HISTORIC AND DESIGN REVIEW COMMISSION

HDRC CASE NO: 2017-207

ADDRESS: 325 W MISTLETOE

OWNER: Window modifications

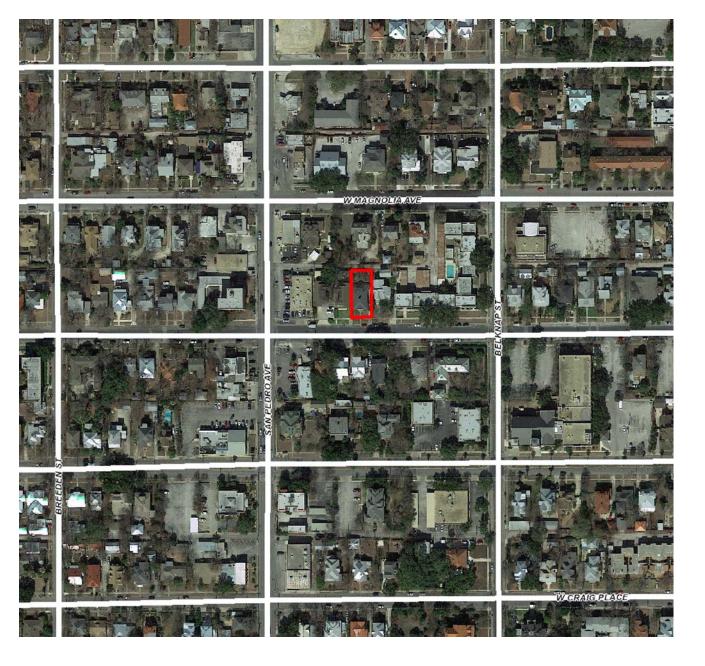
- b. WINDOW REMOVAL The original 6 over 1 window, located directly to the right of the property's main entrance, has been removed and replaced without approval. Administrative approval was granted to repair the original window on August 12, 2016. According to the Guidelines for Exterior Maintenance and Alterations, historic windows should be preserved unless deteriorated beyond repair. The proposed removal and reuse of the 6 over 1 window is not appropriate.

- c. HISTORIC TAX CREDIT VERIFICATION The window was previously deemed repairable when approved for Historic Tax Credit Certification on December 7, 2016. The property is currently in violation for requirements for final Historic Tax Credit Verification and is not eligible for the incentive unless the original window or a salvaged 6 over 1 window is returned in place of the new window.

Staff does not recommend approval of the window replacement based on findings a through c.
